DRB RECOMMENDATION #2

121 15th Ave E. Seattle, WA

SDCI PROJECT NO.:
3020958

MEETING DATE:
09.07.2016

MATERIAL DETAILING

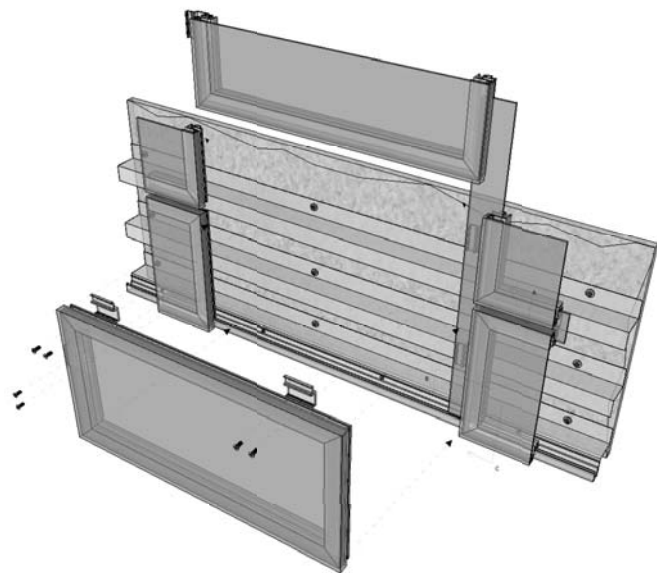
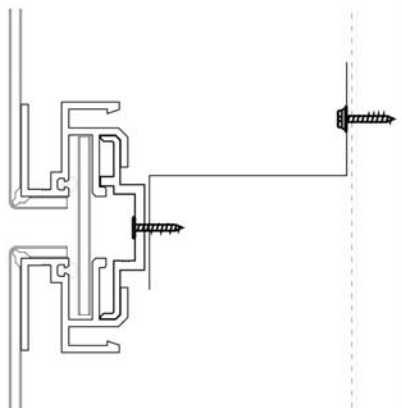
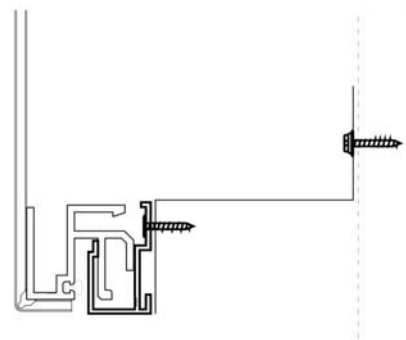
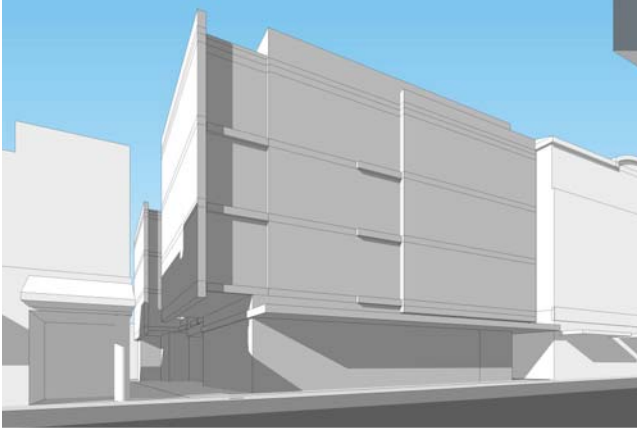
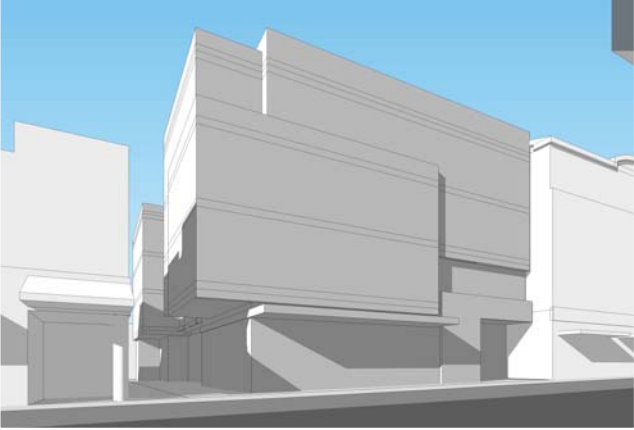
DRB1 REPORT	DESIGN TEAM RESPONSE	REFERENCE
<p>Architectural Design, Composition and Materiality</p> <p>The Board agreed that the street facade had been simplified and supported the massing composition, however the Board also recognized that the largest concern raised at the EDG remains the street facing facade application of materials and detailing. The Board suggested the applicant return with a few alternate designs for the street facing facade based on the guidance provided.</p> <ul style="list-style-type: none">A. The Board struggled with how the design relates to adjacent buildings and creates its own sense of place and identity, and requested renderings with the adjacent buildings superimposed for the next meeting. (CS2-C2, DC2)B. Echoing the public comment, the Board was unanimously concerned with the proposed materials and detailing of the street facing facade. The Board also noted the first floor appears disjointed from the rest of the facade composition. The Board recommended developing a well-proportioned architectural expression through the exploration of materials and detailing. (CS2-C2, DC2, DC4-A1, DC4-I, DC4-II)	<p>Architectural Design, Composition and Materiality</p> <ul style="list-style-type: none">A. The existing adjacent buildings have been superimposed into the design renderings to give a better understanding of how the proposed project relates to the existing structures and fits into the streetscape.B. The proposed building's exterior material pallet at the street facing façade has been upgraded to a higher level quality of materials.B. The first floor street facing façade has been revised to strengthen and blend with the overall building composition and create a more balanced façade.B. Additional exhibits have been added to the package that show 2 alternate material studies for the street facing façade.	<p>See Renderings Pages 30-34</p> <p>See Elevations Pages 22-29</p>

Materials will wrap corners or butt against described details; no material will terminate on an outside corner. The building utilizes a durable and long lasting rain screen system. The details will evolve with the project and as final materials are assigned.

1. FIN END CAP
The fin is defined by a C-channel that caps the end and allows materials to terminate cleanly.

2. ACM PANEL DIAGRAM
Rain screen panel system with preformed corner joints.

3. HORIZONTAL ACM JOINT
With color matching reveal behind.

4. VERTICAL JOINT DETAIL
With color matching reveal behind.

5. ACM BASE DETAIL
Corner termination with Z-clip rain screen.

DEPARTURE 1 & 2 DIAGRAM

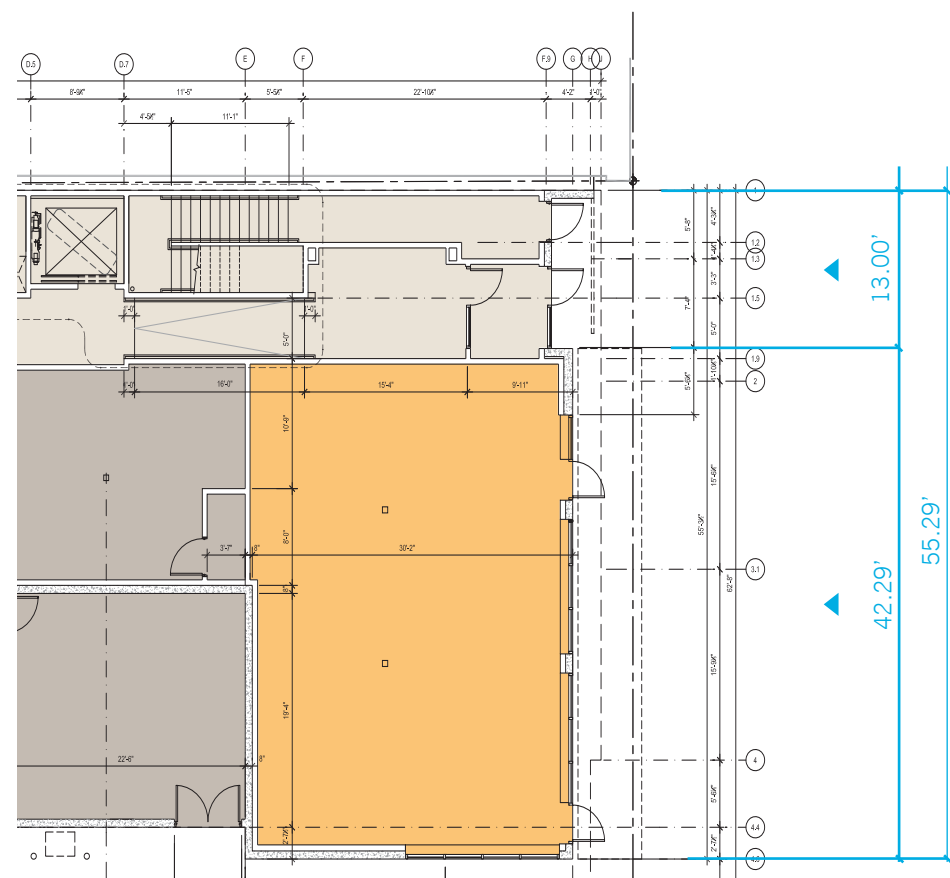
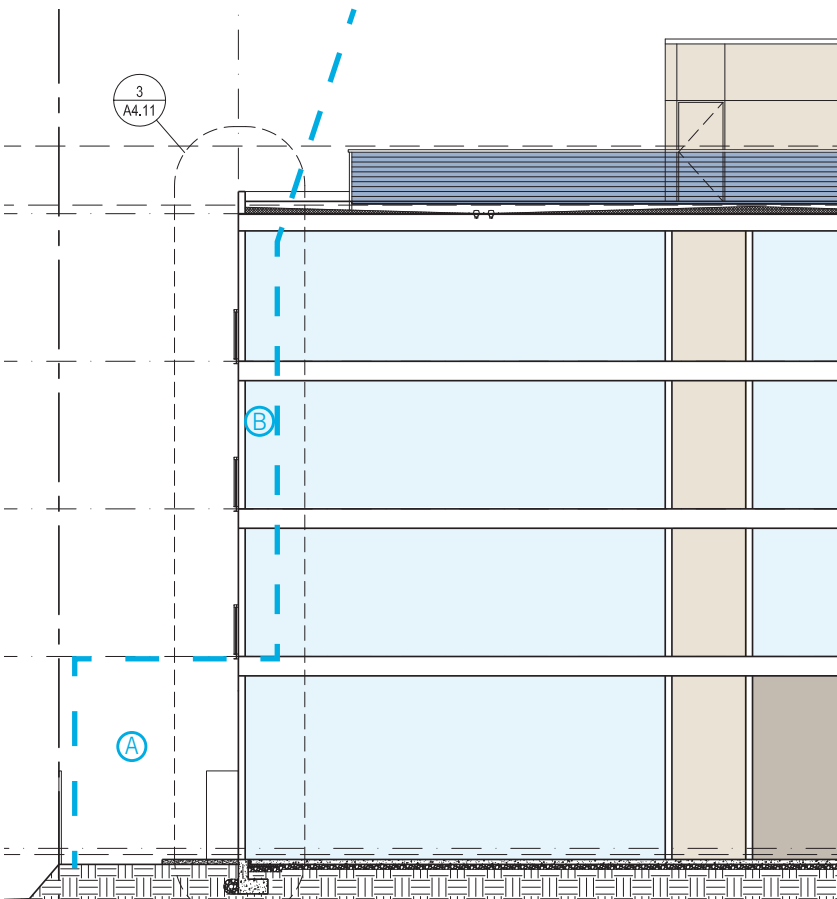
DEPARTURE 1 ADDITIONAL WIDTH AT STREET FRONT FOR RESIDENTIAL EGRESS	DEPARTURE 2 ADDITIONAL WIDTH AT STREET FRONT FOR RESIDENTIAL EGRESS	DEPARTURE 3 REAR SETBACK ADJUSTMENT
CODE CITATION:	SMC 23.47A.008 C1	SMC 23.47A.008 C1	SMC 23.47A.014
PROPOSED:	We request a departure to allow for required residential egress. 13.00' is required for residential egress, approximately 24% of the proposed 55.29' street-facing facade. The secondary residential egress to the North is also recessed 5' to help influence the permitted use on the street-level as more dominant.	We request a departure to allow for required residential egress. 14.38' is required for residential egress, approximately 26%of the proposed 55.30' street-facing facade. The secondary residential egress to the North is also recessed 5' to help influence the permitted use on the street-level as more dominant.	We propose a minimum setback of 10'-2" (average of 11'-2") in order to maintain green space and privacy at ground level at the rear property line. The volume gained through the departure (B) is less than the code compliant volume that will remain unbuilt (A). (The proposed departure also places the building out of critical root zone of an exceptional tree on adjacent west property.)

CODE REQUIREMENT:	A minimum of 80 percent of the width of a structure's street-level street-facing facade that faces a principal pedestrian street shall be occupied by uses listed in subsection 23.47A.005.D.1.	The remaining 20% of the street frontage may contain other permitted uses and/ or pedestrian entrances. Along designated principal pedestrian streets, one or more of the following uses are required along 80 percent of the street-level street-facing facade in accordance with the standards provided in subsection 23.47A.008.C	Requires a setback for structures with more than one residential unit along the rear lot line abutting a residentially-zoned lot.
ADDITIONAL INFO:	Total Ground Floor Width: 55.29 Commercial Width: 42.29' (76%) Residential Width: 13.00' (24%)	Total Ground Floor Width: 55.29 Commercial Width: 42.29' (76%) Residential Width: 13.00' (24%)	A: 9084.72 CU FT unbuilt inside allowable area B: 7909.33 CU FT proposed in setback
